Draft CATEX Checklist

Action Name: Dept. of State Potomac Hill Permanent Security Fence

Potomac Annex Fence
draft Preferred Alternative Progression
January 31, 2020

RE: Fire Department Access Road Dispute between the United States Department of State and United States Institute of Peace

OPTION 4.1.1
dated December 19, 2019

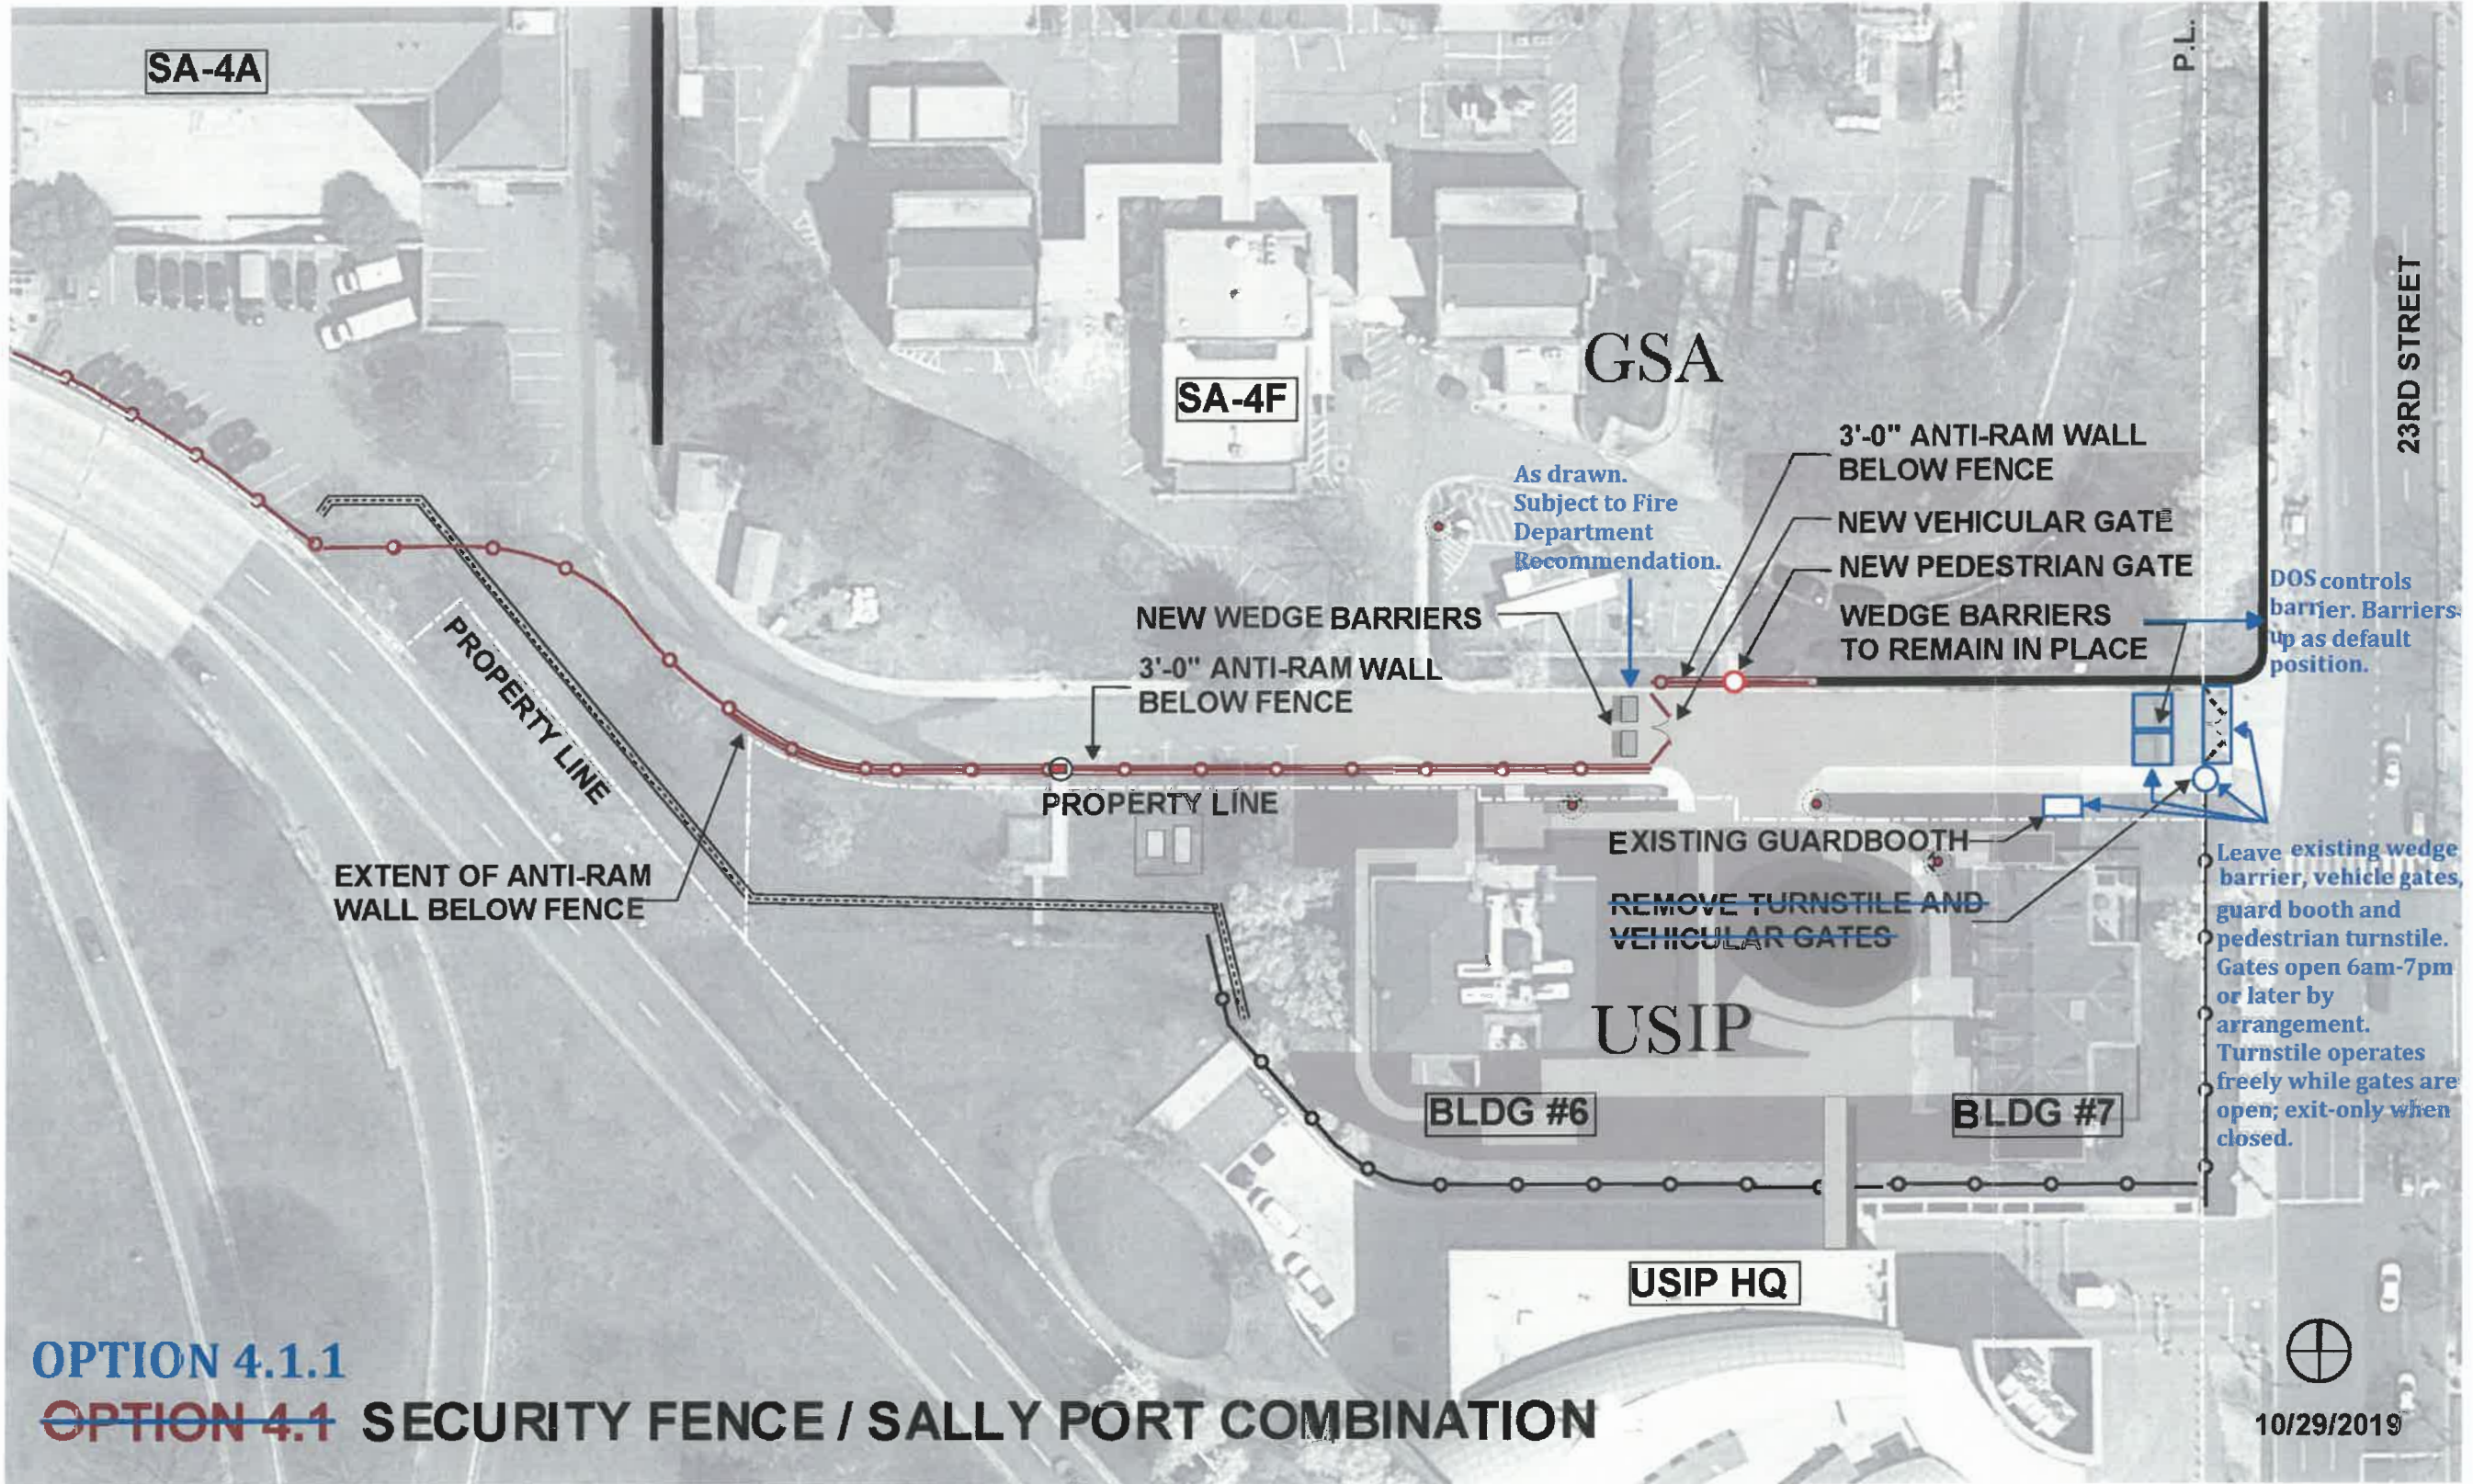
1. Start with Option 4.1 as drawn by DOS.
2. At 23rd Street, leave existing wedge barrier, vehicle gates, guard booth, and pedestrian turnstile.
 - a. Wedge barrier to remain up as default position, under control of DOS and lowered as needed for passage by vehicles approved by DOS or USIP.

- b. Vehicle gates to remain open on workdays from 6 AM to 7 PM, per MOU; to remain open later than 7PM upon USIP request to accommodate an evening event, with USIP reimbursement of DOS cost of later closing.

- c. Guard booth to be manned by USIP at its option.
 - d. Turnstile to remain in place, allowing two-way passage while vehicle gates are open and set to allow exit only when gates are closed.

3. No change from Option 4.1 for new DOS wedge barrier, vehicle gates, pedestrian access north from C Street, or new fence on south side of C Street except as recommended by Fire Department. New DOS guard booth to be located north of C Street at location determined by DOS.

NOTE: None of the tweaks compromise the DOS security perimeter established by Option 4.1. The changes relate only to access to the DOS-administered portion of C Street and to USIP-administered property. Leaving the wedge barriers up adds a layer of security (a second set of wedge barriers) to DOS property not provided by Option 4.1.

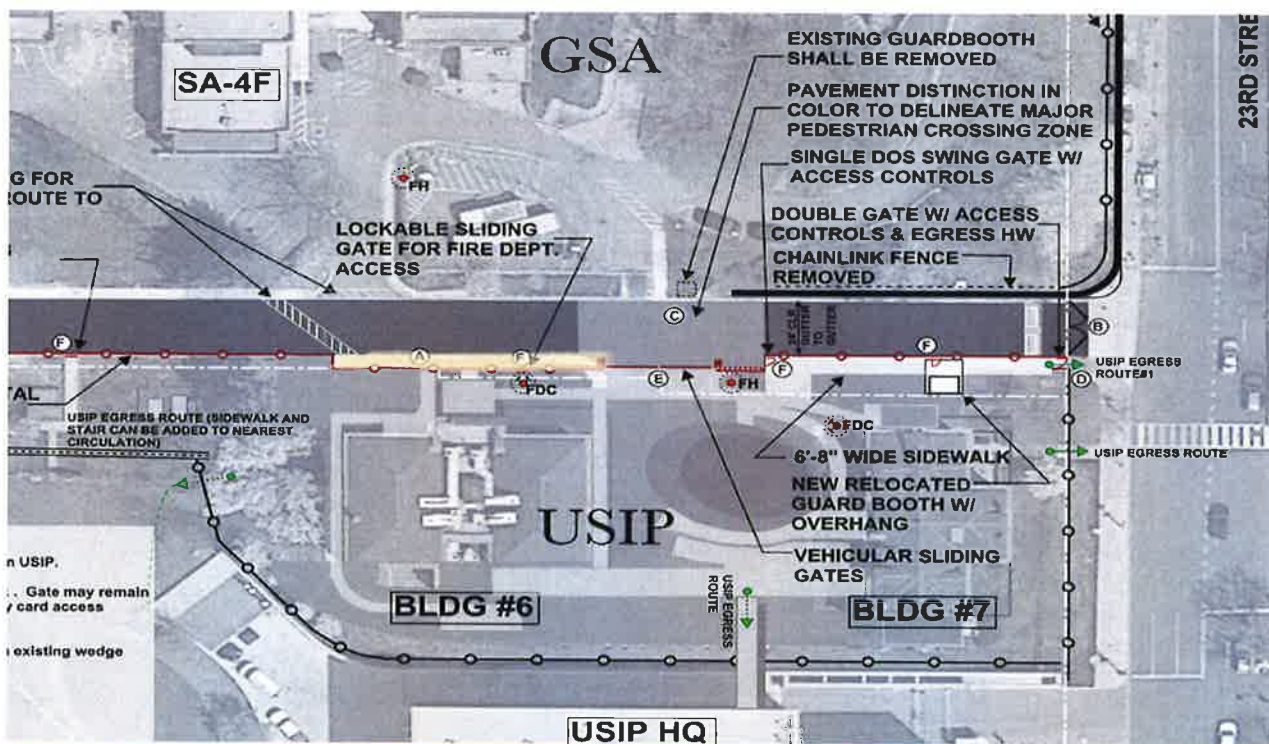
Additionally, based on my November 12th site visit, the temporary gate that is currently in place shows that fire department access to the fire service features of the United States Institute of Peace buildings are compromised at this time. The fire hydrant and fire department connection are blocked by fencing. These are violations of the fire code and would be ordered corrected for other buildings within the city.

The gate installed should be the type that has sliding access openings as those presented in the drawing below. This will prevent blocking any portion of the current fire department access in place upon its opening. Additionally, the gate should be designed so that the sliding access opening has the required dimensions to accommodate fire apparatus access to the grounds of the United States Institute of Peace.

Further, the gate should be constructed as to provide clear and unobstructed access to the fire hydrant and the fire department connection on the property of the United States Institute of Peace. Also, the sidewalk area in front of the FDC for Building No. 6 should be fenced in a way that makes it accessible on the United States Institute of Peace side.

To resolve these concerns, it is my recommendation that the United States Department of State ensure that the proposed gate is installed in accordance with the fire code section below.

503.6 Security gates. Where security gates are installed across fire access roads, they shall have an approved means of emergency operation. The security gates and the emergency operation shall be maintained operational at all times. Electric gate operators, where provided, shall be listed in accordance with UL 325. Gates intended for automatic operation shall be designed, constructed and installed to comply with the requirements of ASTM F 2200. (IFC)
